1 SUBDIVISION - 46 TIVENDALE ROAD - DEFERRED ITEM

FILE REFERENCE INT1764302

That a Refusal to Grant Planning Permit T160693 be issued for a subdivision and associated works at 46 Tivendale Road, Officer for reasons in this report.

APPLICATION NO:	T160693
APPLICANT:	Calibre Consulting for Sweet 46 Property Developments Pty Ltd
LAND:	Lot 6 PS66670, 46 Tivendale Road, Officer
PROPOSAL:	Staged subdivision and associated works
PLANNING CONTROLS:	Urban Growth Zone Schedule 3 Development Contributions Overlay Schedule 4 Clause 52.01 Public Open Space Clause 52.16 Native Vegetation Precinct Plan Clause 52.36 Integrated Public Transport Planning Clause 56 Residential Subdivision Clause 65 Decision Guidelines Officer Precinct Structure Plan September 2011 Cardinia Creek Conservation Management Plan Officer Native Vegetation Precinct Plan September 2011, Officer Development Contributions Plan and Conservation Management Plan 15 September 2011.
NOTIFICATION & OBJECTIONS:	The application was not required to be advertised under Clause 37.07-13 of the Urban Growth Zone.

Plan 5: Future Urban Structure

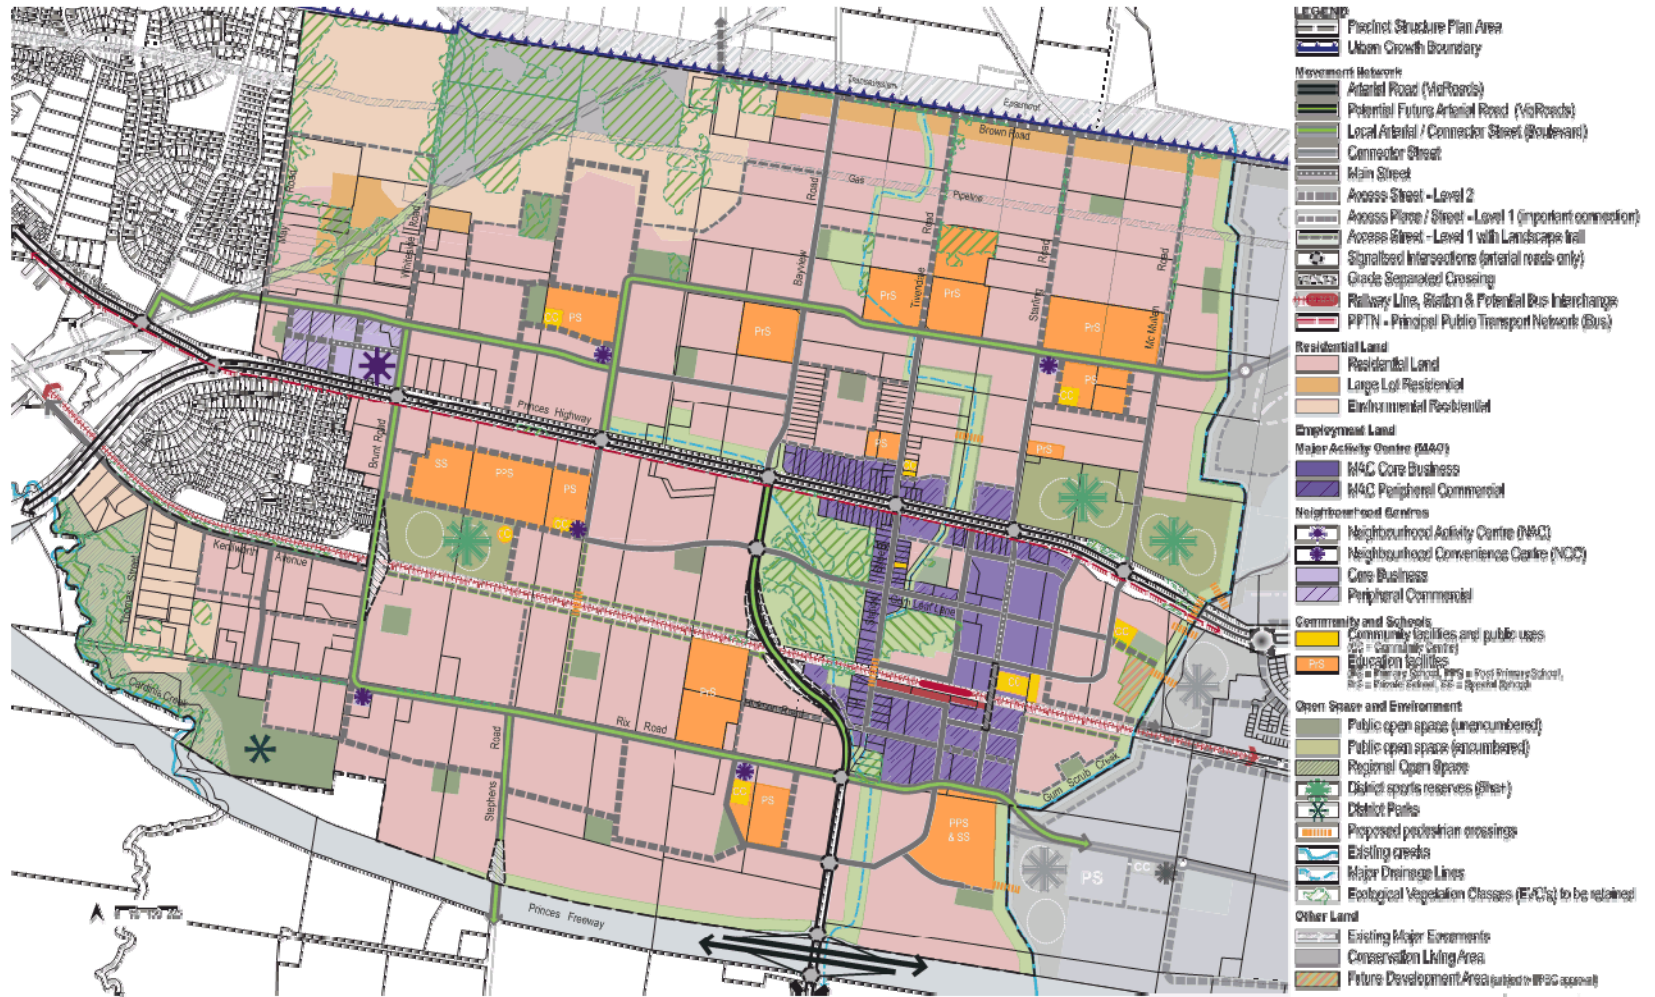
Plan 5 Future Urban Structure, describes how the PSP delivers the vision. It is considered that the proposed subdivision is not generally in accordance with plan 5 as the drainage corridor has been substantially reduced in size.

The reduction of the drainage corridor further inhibits the ability for the corridor to become a highly permeable and walkable open space trail network that the PSP envisages it to be.

Plan 6: Land Use Budget

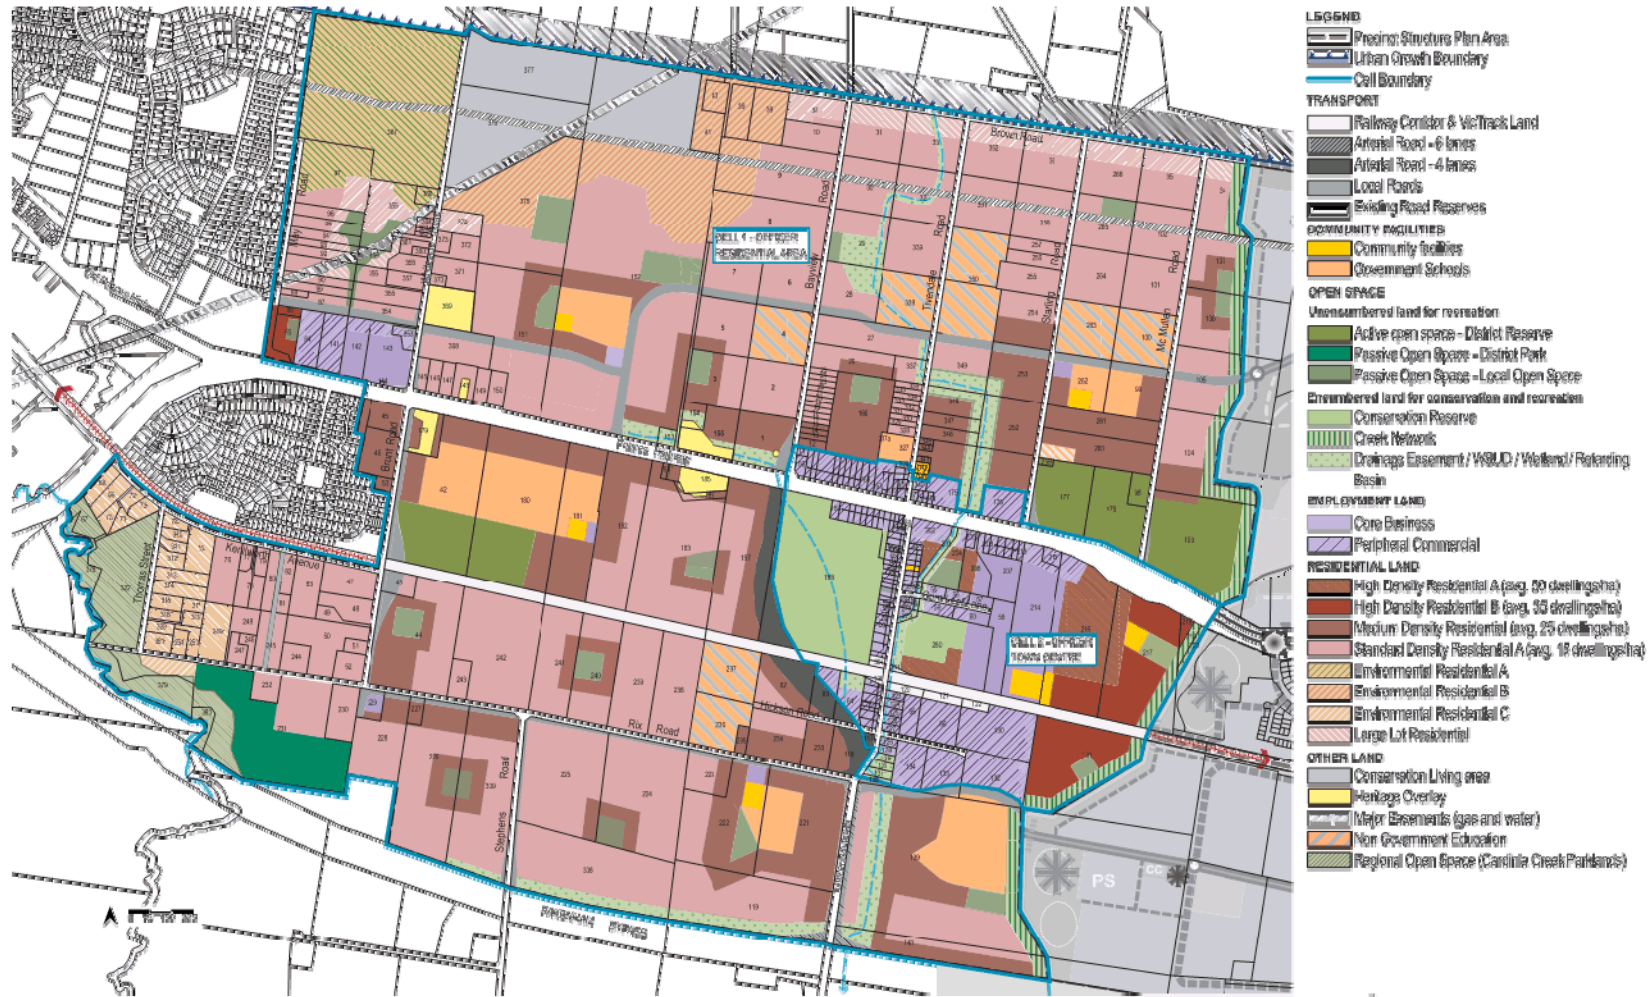
Plan 6 Officer Land Use Budget, the site is shown as property number 349.

- Local Roads Including Boulevard Connector - 0.69ha (not included in the net developable area - NDA)
- Drainage easement/WSUD/Wetland/Retarding Basin – 1.19ha (not included in the NDA or OS%)
- Local Open Space – 0.21ha (not included in the NDA or OS%)
- Total property area 4.02ha and total NDA – 1.93ha

In response to the above, the proposal does not comply with the land use budget as the areas as described above have not been achieved within the proposed plan. The most concerning figure is the applicant is proposing to only deliver 4,370sqm of drainage easement/WSUD/wetland/Retarding Basin land instead of the approximately required 11,190sqm required by the PSP

Plan 11: Open Space Network

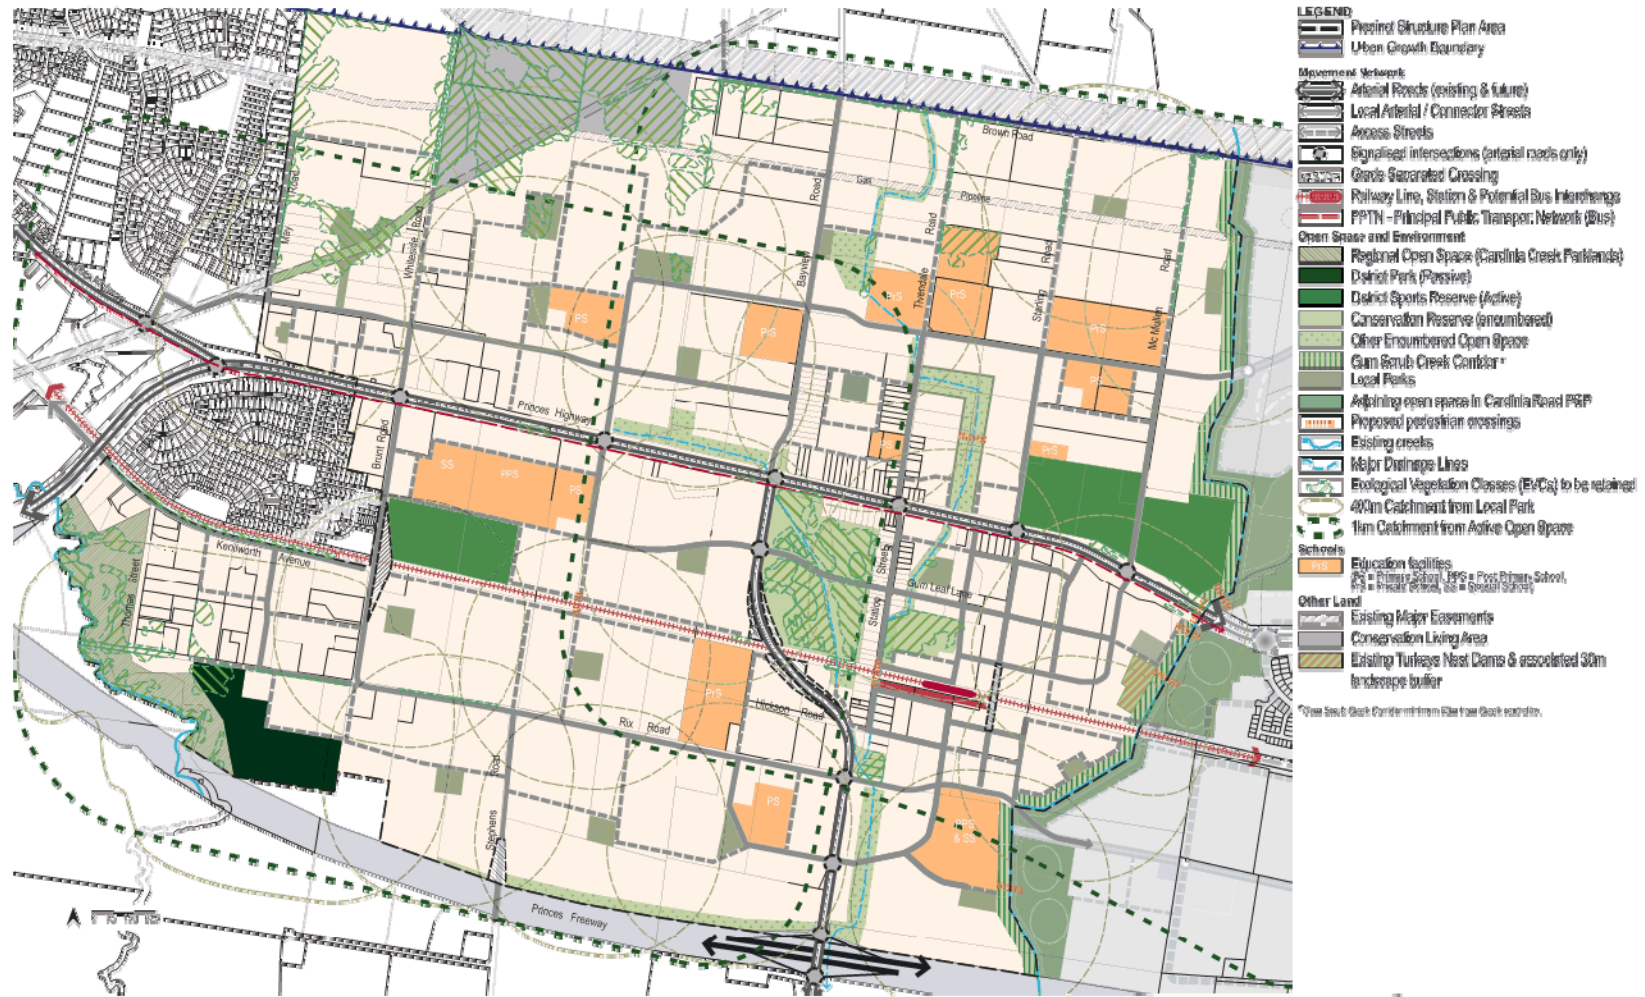
Plan 11 Open Space Network identifies the site as being partly encumbered and encumbered public open space with a major drainage line.

In response to the above, it is considered that the proposal fails to meet the relevant planning and design guidelines to be met as the reduction of the drainage corridor does not allow for the

adjoining retarding basins to be well aligned and integrated into the broader open space network. The network is intended to be consistent through each site as shown within the PSP.

Plan 12: Integrated Water Management

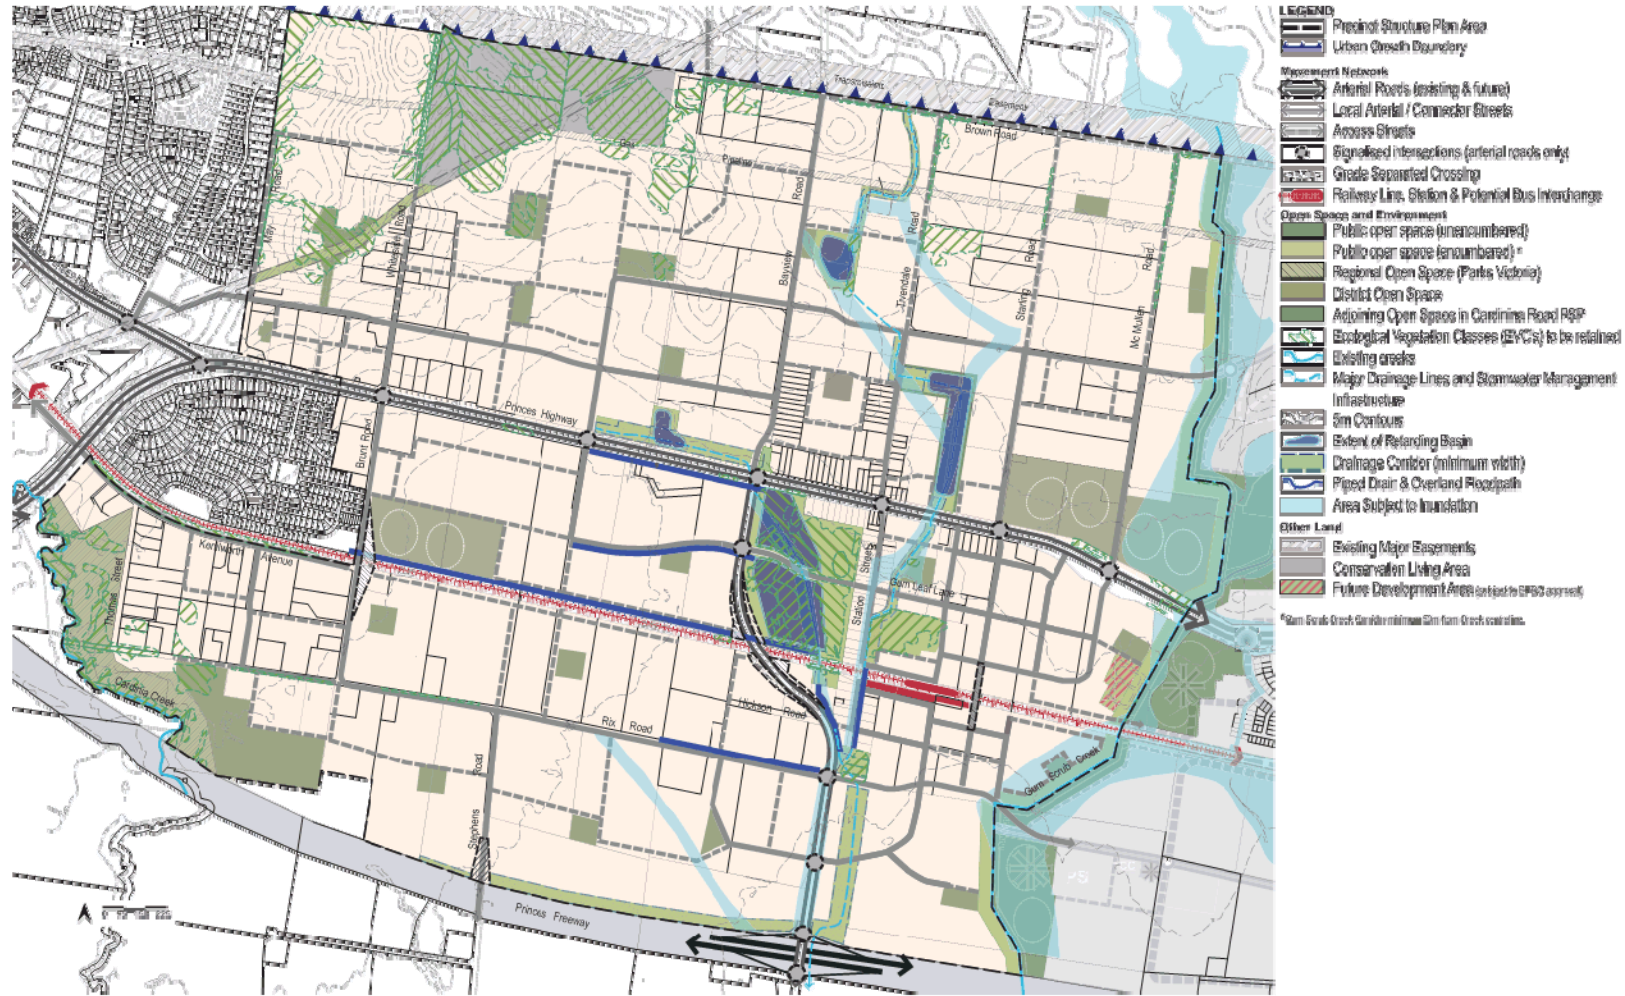
Plan 12 Integrated Water Management identifies the site as being part of a wider drainage corridor and having a retarding basin within it. The south west corner of the land is identified within the land subject to inundation overlay over it.

The area subject to inundation and drainage corridor extends from the north to the south of the Officer PSP boundary. The drainage corridor follows a specific drainage line that meets with retarding basins and open space. The role of encumbered land is to provide for overland flows and stormwater retention and to maintain access to services.

Plan 17: Walking and Trails

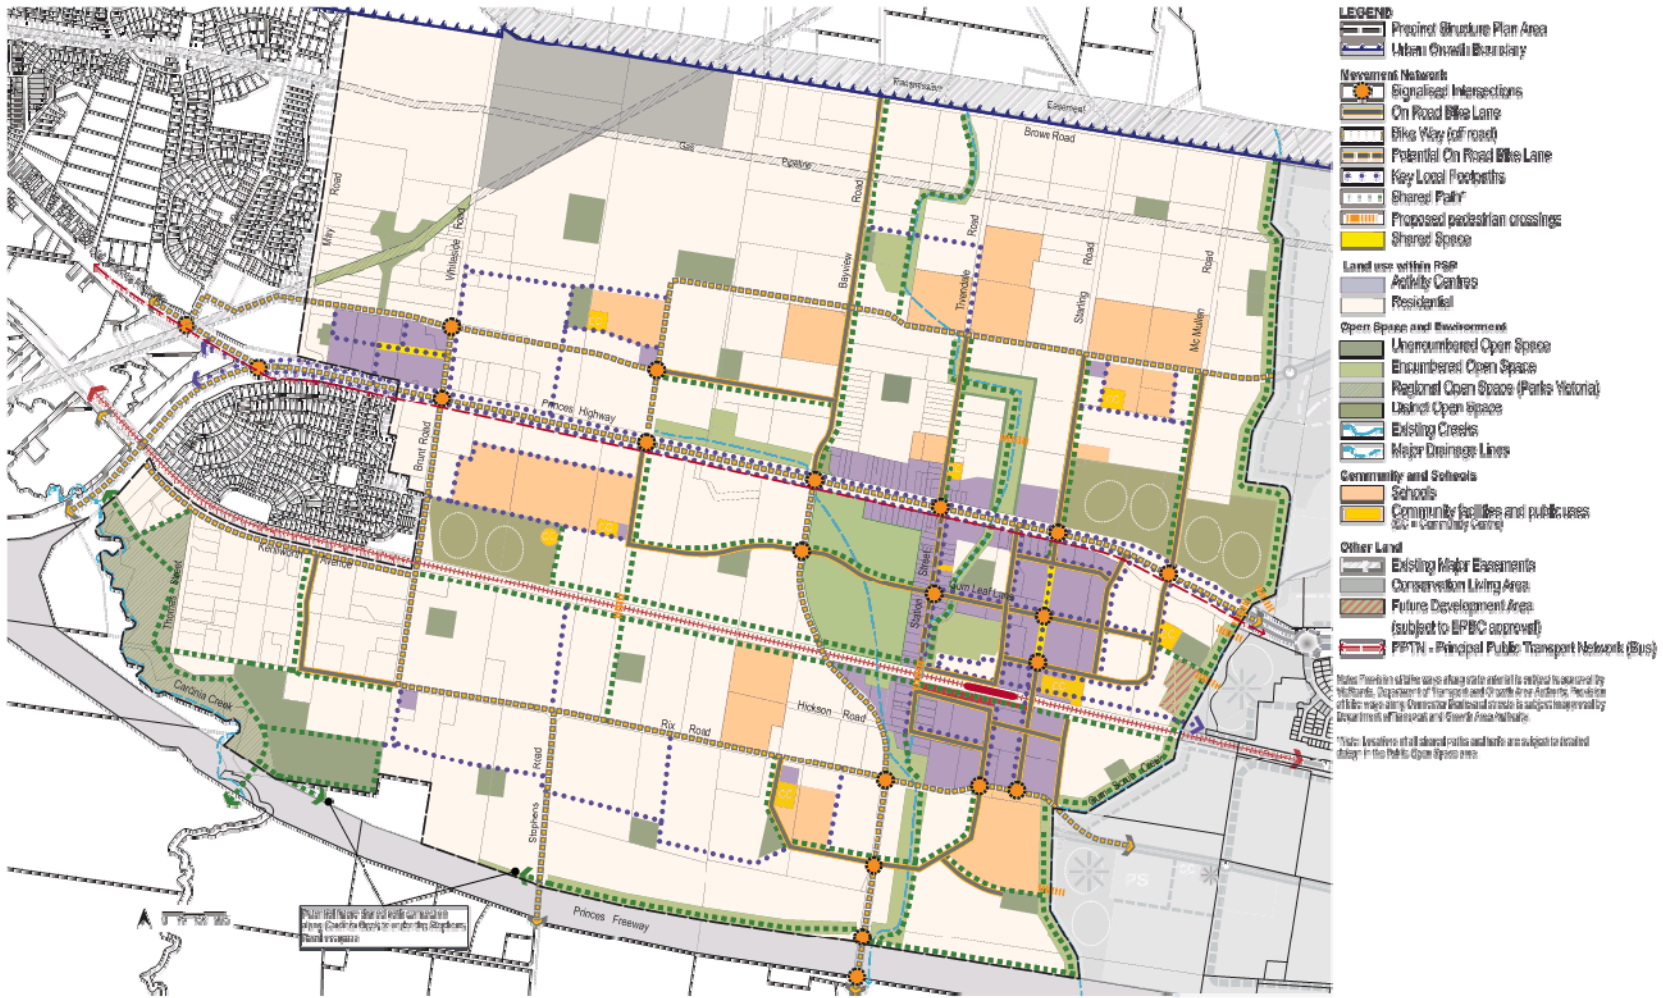
Plan 17 Walking and Trails shows a shared path within Tivendale Road and within the drainage corridor.

In response to the above, a 2.5 metre wide shared path along and within the open space network, in particular along the drainage network and provision of landscaping must be provided to achieve the objectives of the PSP, at present the reduction of the drainage corridor fails to achieve these outcomes.
